Form 3160-5  
(August 2007)UNITED STATES  
DEPARTMENT OF THE INTERIOR  
BUREAU OF LAND MANAGEMENTFORM APPROVED  
OMB No 1004-0137  
Expires July 31, 2010**SUNDRY NOTICES AND REPORTS ON WELLS**  
*Do not use this form for proposals to drill or to re-enter an abandoned well. Use Form 3160-3 (APD) for such proposals.*5 Lease Serial No.  
NMNM113387

8 Well Name and No  
Frontier 9 Fed Com #19 API Well No.  
30-015-3592010 Field and Pool or Exploratory Area  
huepeche, morrow11 Country or Parish, State  
Eddy County, NM**12. CHECK THE APPROPRIATE BOX(ES) TO INDICATE NATURE OF NOTICE, REPORT OR OTHER DATA**

Corkran Energy, LP  
NM-113387: Frontier 9 Fed Com #1  
API: 30-015-35920  
Eddy County, New Mexico

RE: Plugging and Abandonment Requirements, Conditions of Approval

Proposed Wellbore

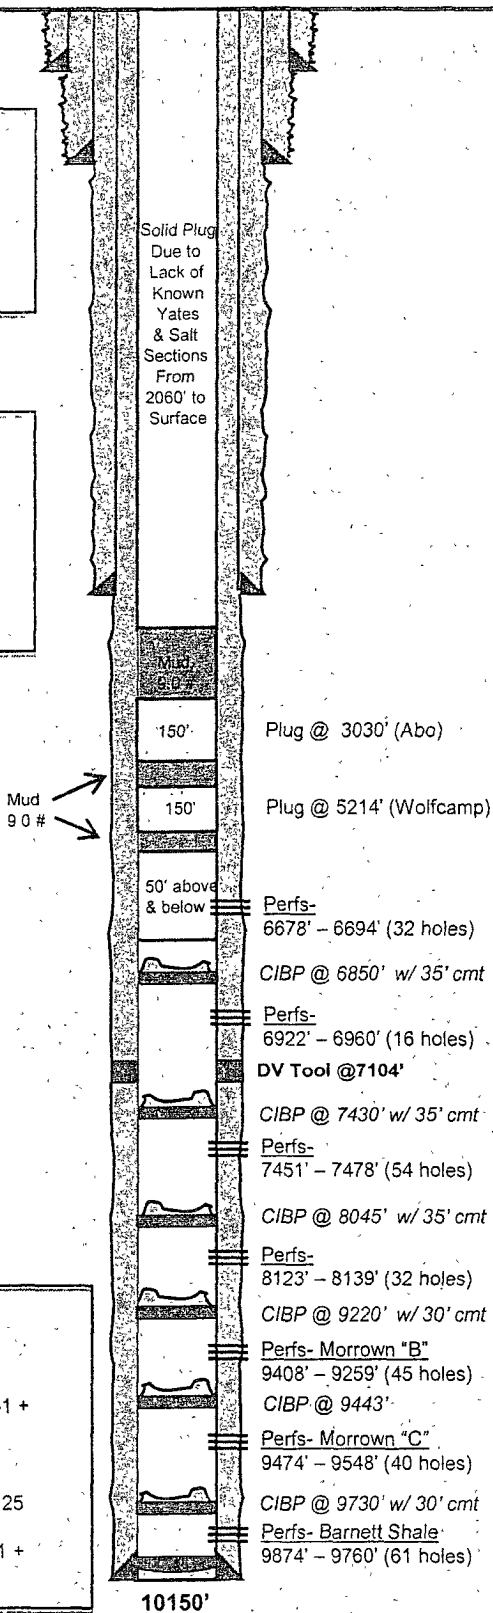
1. OK
2. Cement plug to be a minimum 160' in length. Plug from 6744'-6584'. WOC and tag at 6584' or shallower. (Perfs)
3. OK
4. Plug from 5264'-5114'. WOC and Tag at 5114' or shallower.
5. OK
6. Plug from 3080'-2930'. WOC and tag at 2930' or shallower.
7. OK
8. OK
9. OK – Verify top of cement in casing and all annuluses before placing P&A cap.
10. Submit a subsequent report to the BLM.
